**RESPONSE TO COMMENTS FOR THE OPERABLE UNIT 4 COMPLEX SILOS 1&2
REMEDICATION FACILITY IMPLEMENTATION PLAN FOR ABOVE-GRADE
DECONTAMINATION AND DISMANTLEMENT**

**OPERABLE UNIT FOUR COMPLEX SILO 1&2
REMEDICATION FACILITY
IMPLEMENTATION PLAN**

DOCUMENT NUMBER 40900-PL-0004 (REV. 0) PCN2

OPERABLE UNIT 4 (OU4) COMPLEX SILOS 1&2 REMEDIATION FACILITY IMPLEMENTATION PLAN FOR ABOVE-GRADE DECONTAMINATION AND DISMANTLEMENT

94D - CARBON BED FACILITY

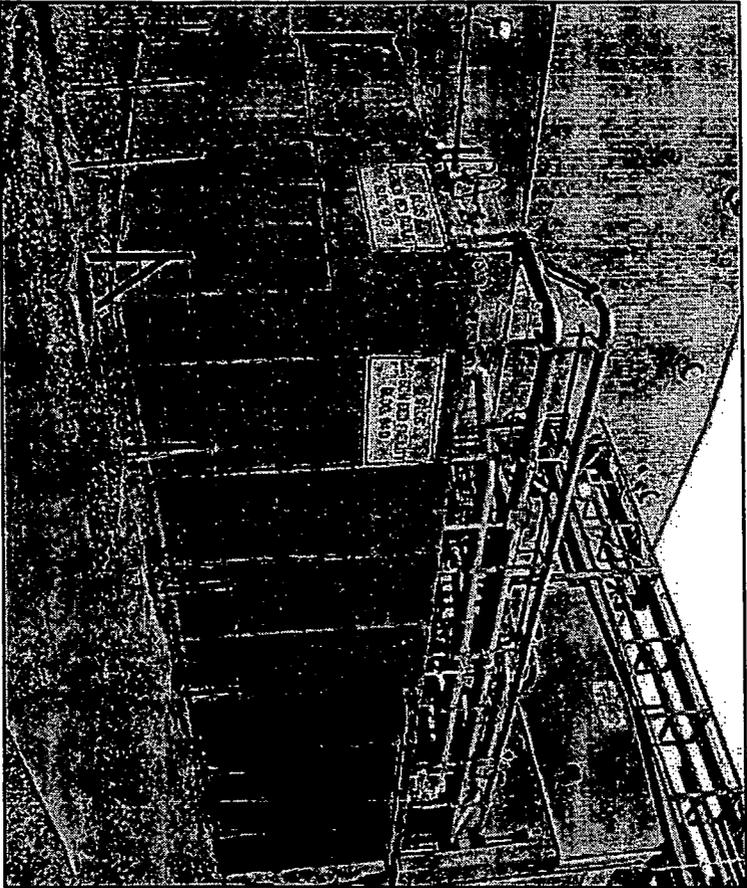
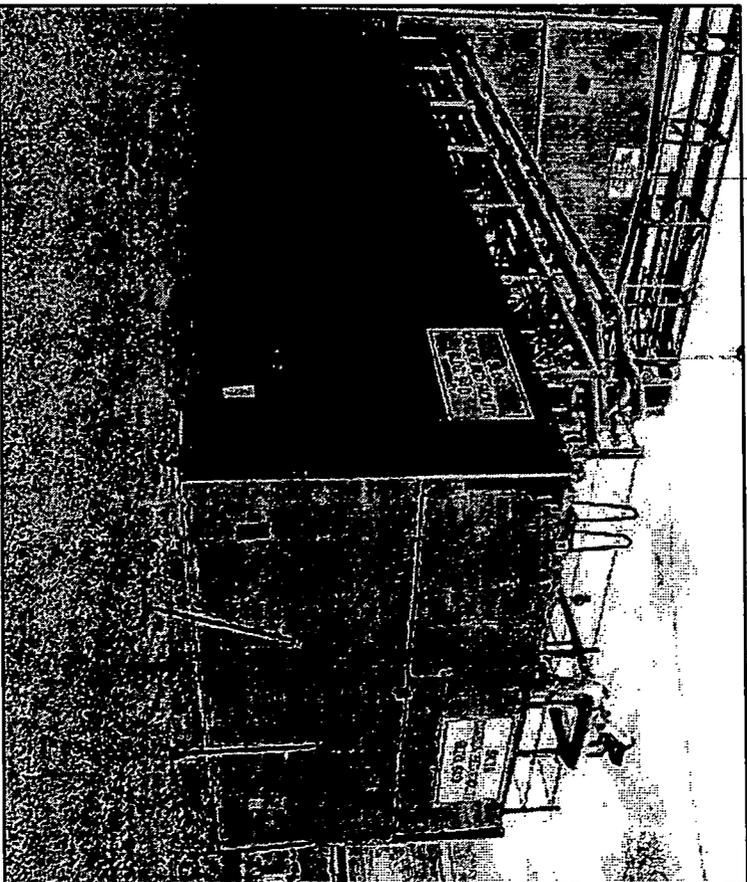
Comment: Photographs for the Carbon Bed Facility are labeled as "94B - Carbon Bed Facility." The photographs should be labeled as "94D - Carbon Bed Facility."

Response: The Appendix D, Page 4 photographs have been changed to read: "94D - Carbon Bed Facility."
